HISTORIC AND DESIGN REVIEW COMMISSION

June 06, 2018

HDRC CASE NO: 2018-256
ADDRESS: 139 E COMMERCE ST
141 E COMMERCE ST
106 RIVER WALK
143 E COMMERCE ST
145 E COMMERCE ST
147 E COMMERCE ST
149 E COMMERCE ST
151 E COMMERCE ST
LEGAL DESCRIPTION: NCB 106 BLK LOT 27
NCB 106 BLK LOT 28
NCB 106 BLK LOT 29 & 30
NCB 106 BLK LOT 31
ZONING: D, HS
CITY COUNCIL DIST.: 1
LANDMARK: Commercial Building
APPLICANT: Keller Henderson/Keller Henderson Interiors
OWNER: Burgos LP/Uriarte LP
TYPE OF WORK: Demolition with new construction of seventeen story, residential tower with retail
APPLICATION RECEIVED: May 11, 2018
60-DAY REVIEW: July 10, 2018
REQUEST:

The applicant is requesting conceptual approval to:

COMMERCE STREET ELEVATION

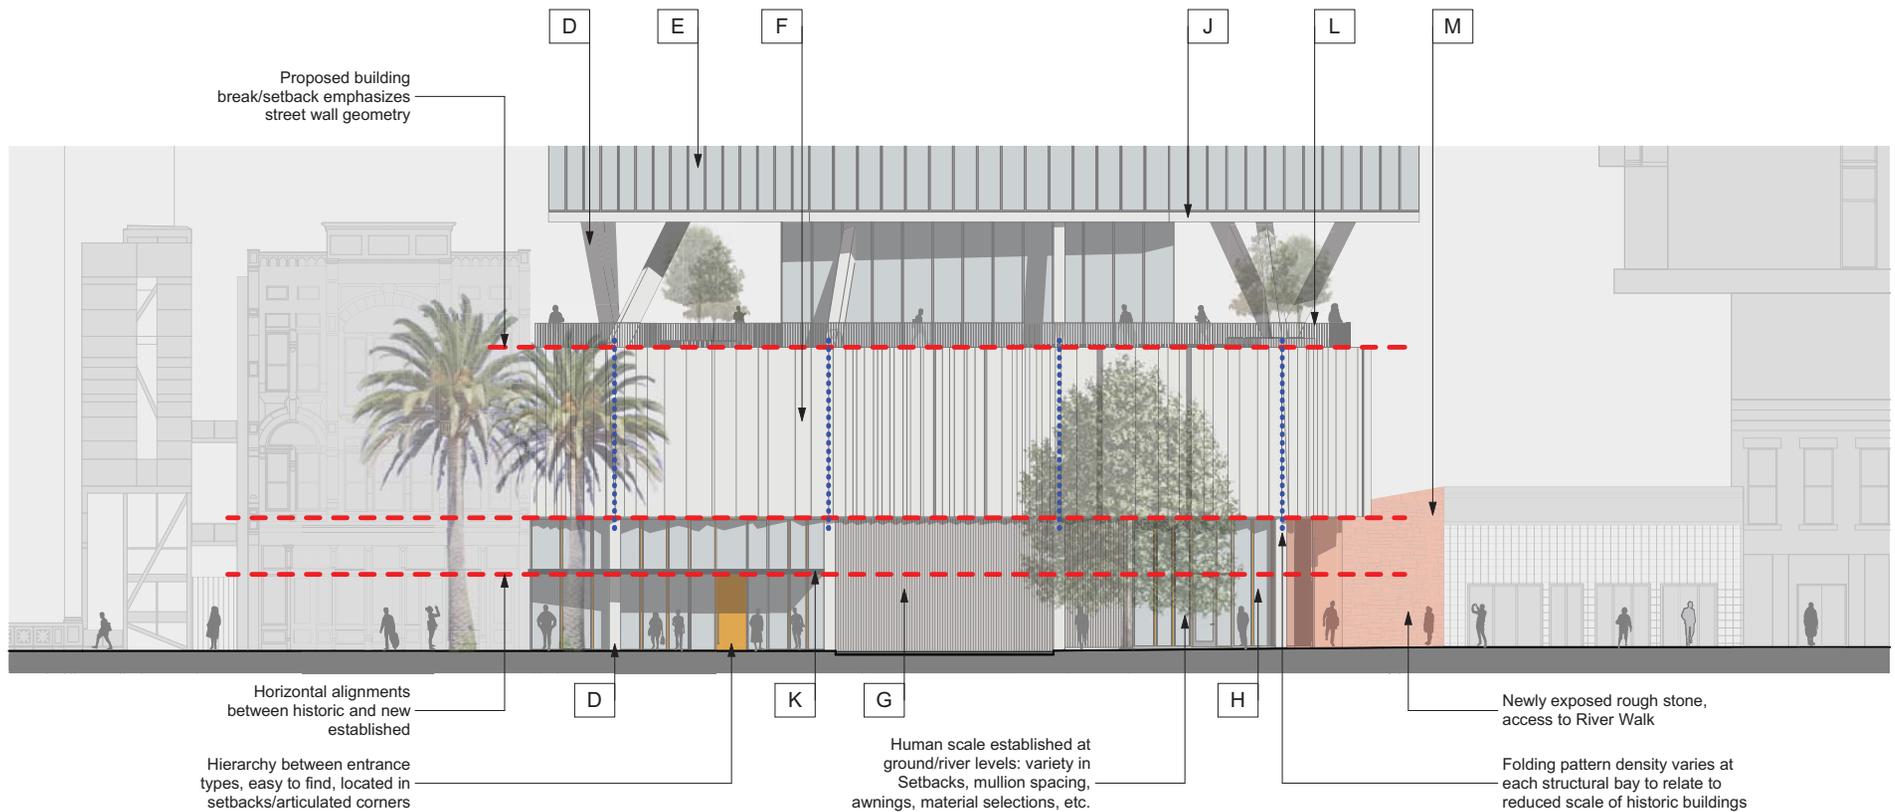
- v. That the proposed recessed pedestrian entrance on the E Commerce façade be modified to not be recessed, but rather align with the adjacent historic structures to provide continuity within the street wall.

- vi. That a ground-level canopy be extended across the entirety of the E Commerce façade to bring the project down to a pedestrian scale and provide shade.

RIVER WALK PLAN

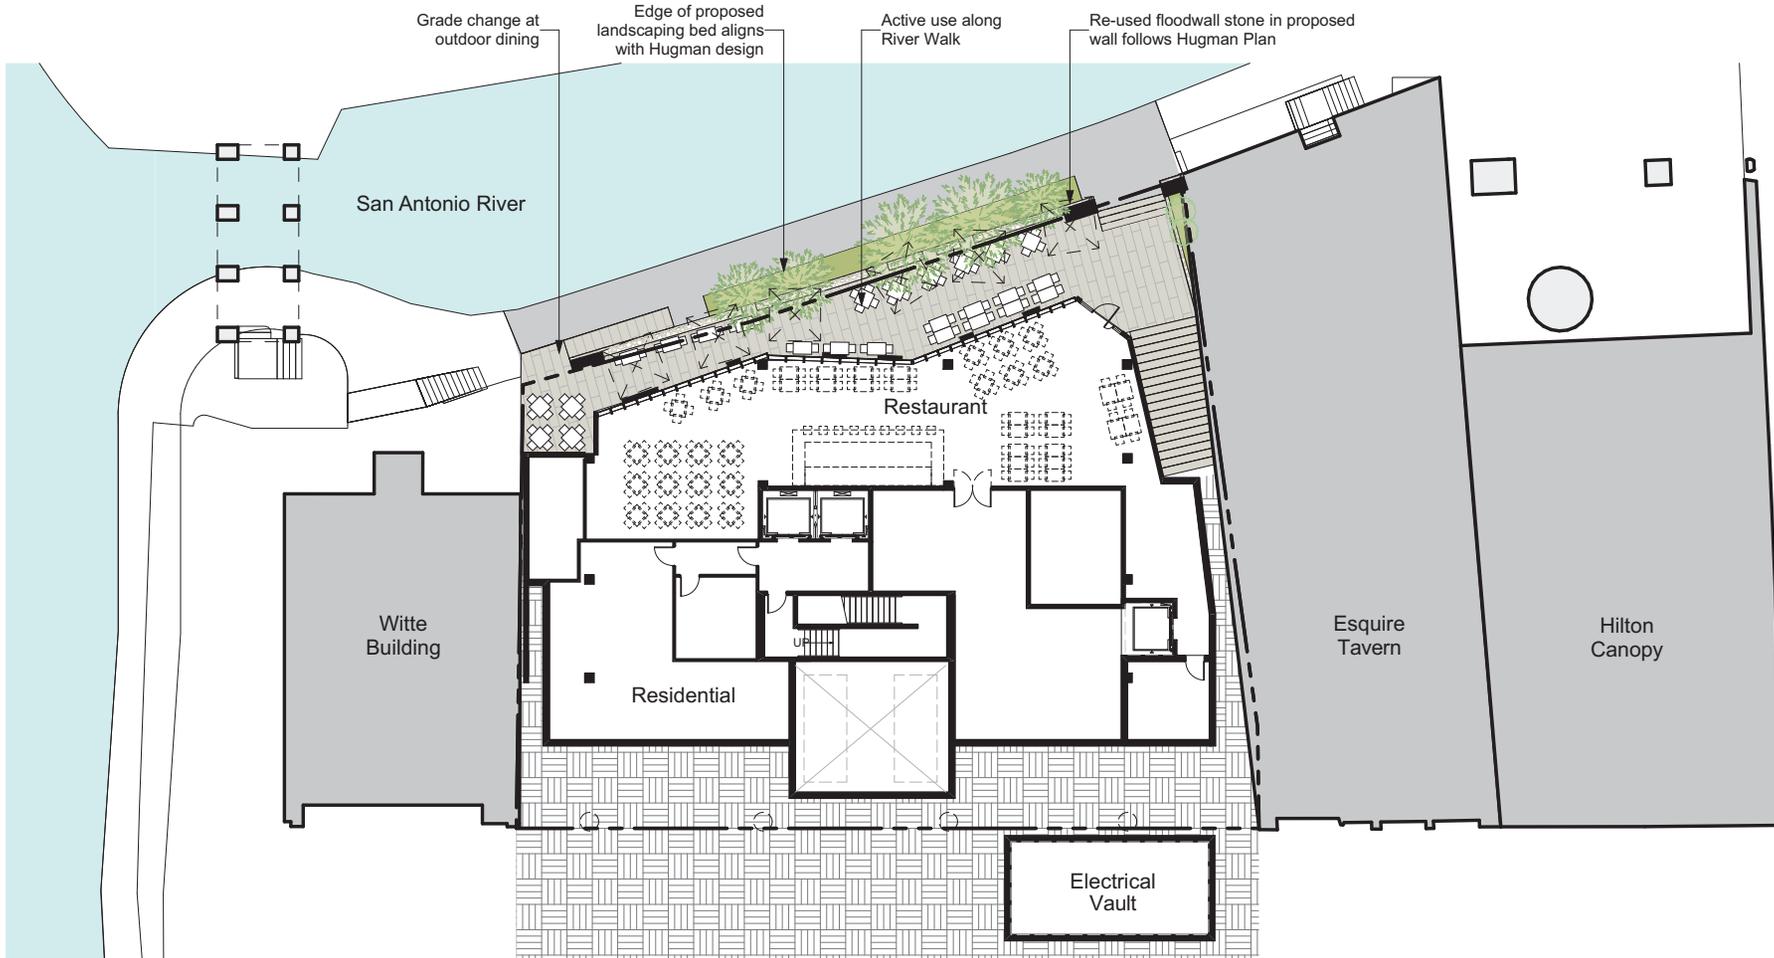
- ii. That the applicant provide information regarding the screening of all service and mechanical equipment as noted in finding 2l.
- iii. That the applicant continue to develop the paseo, River Walk and street levels to incorporate more historic stone including a taller portion of the wall along the River Walk. The applicant should substantially increase the amount of historic wall that will be retained and incorporate taller portions into the design.

- iv. That the applicant make every attempt to salvage and replant the existing fig tree located in the stone wall on the River side of the property. The tree should be replanted in a similar location that readily visible from the River Walk. The applicant is responsible for coordinating and documenting these efforts with the City arborist and implementing any mitigation if recommended by the HDRC.
